## Addendum

### Access Summerside - Interior Modifications Project #2060-18045

**ADDENDUM # 1**

**Date : December 10, 2018**

Project Title: <b>Access Summerside Interior Modifications</b>			Drawing Title: <b>Area to receive new Carpet</b>			
	Date:	Dsgn By:	Drn By:	Scale:	Proj No.:	Dwg No.:
	Dec 10, 2018	TIE	J.Gauthier	1:150	<b>2060 - 17090</b>	<b>SK1</b>

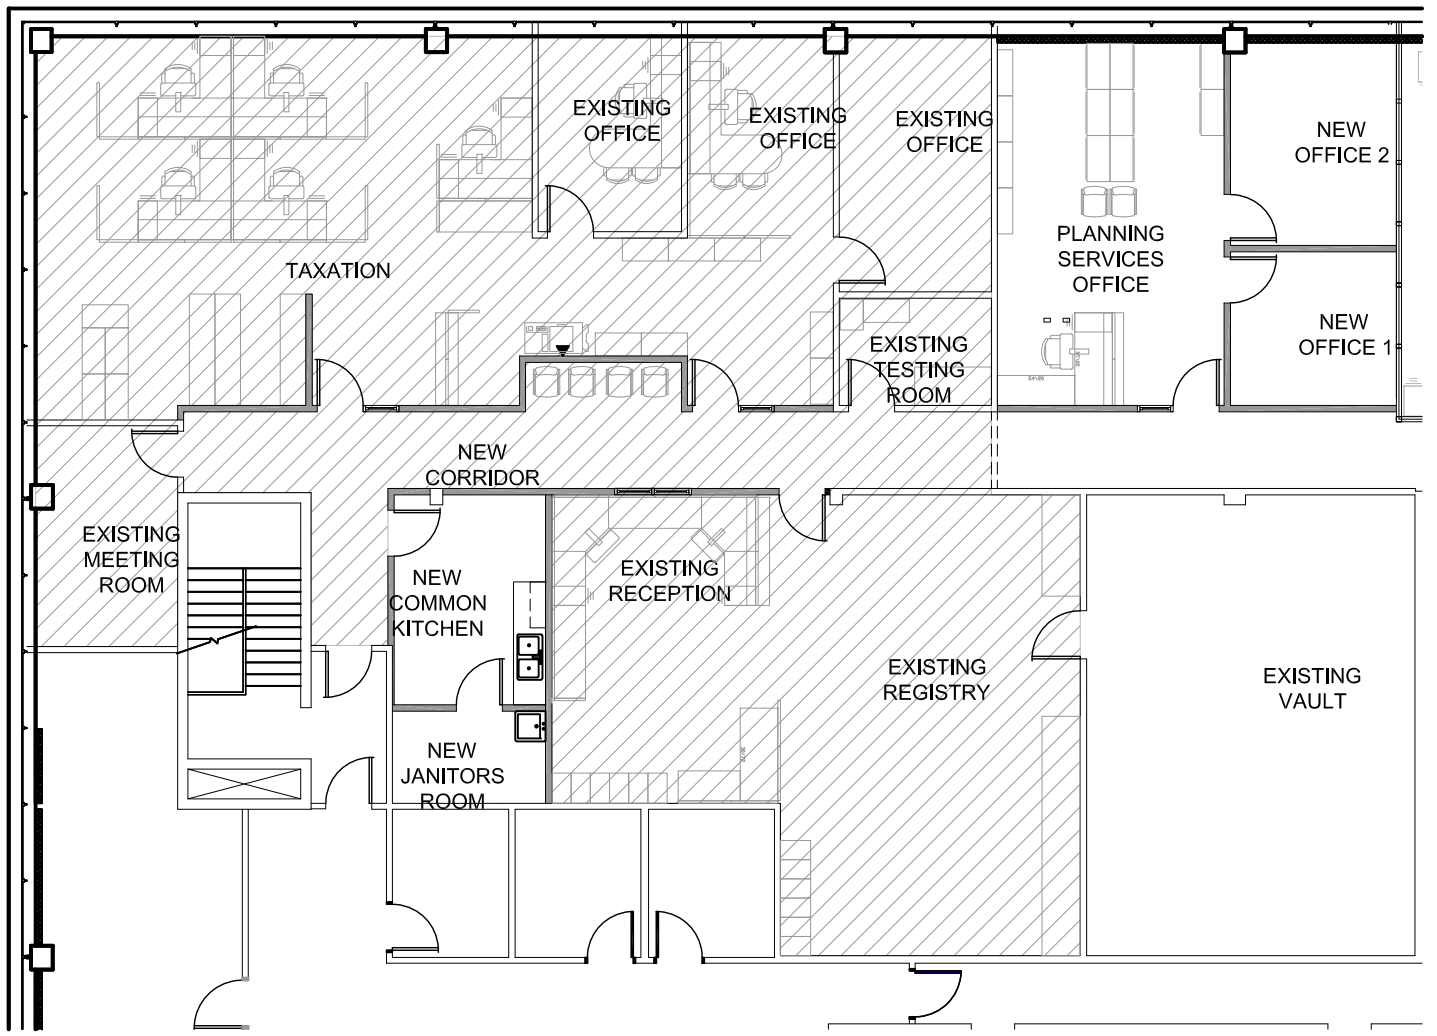
**Refer to attach Sketch SK1- New Carpet Tile and Wall Base:**

Hatched area on attached SK1 to receive new carpet tile to match existing carpet tile. Contractor to allow for removal and disposal of existing carpet within the area to receive new carpet tile.  
All new carpeted areas to receive new wall base to match existing.

HATCHED AREA INDICATES AREA TO RECEIVE NEW CARPET TILE - APPROX 3,000 SQ.FT. CONTRACTOR TO CONFIRM.

CARPET TILE: CONTRACTOR TO CONFIRM AND MATCH EXISTING CARPET TILE PATTERN, COLOUR AND SIZE ON SITE, WHICH IS LISTED BELOW.

INTERFACE FLOR "THE STANDARD"  
 COLOUR : FLANNEL #9369  
 SIZE: 50CM X 50CM  
 INSTALL: NON-DIRECTIONAL  
 NO ALTERNATES OR SUBSTITUTIONS

WALL BASE: CONTRACTOR TO MATCH SIZE AND COLOUR OF EXISTING WALL BASE WHERE EXISTING CARPET TILES ARE INSTALLED.
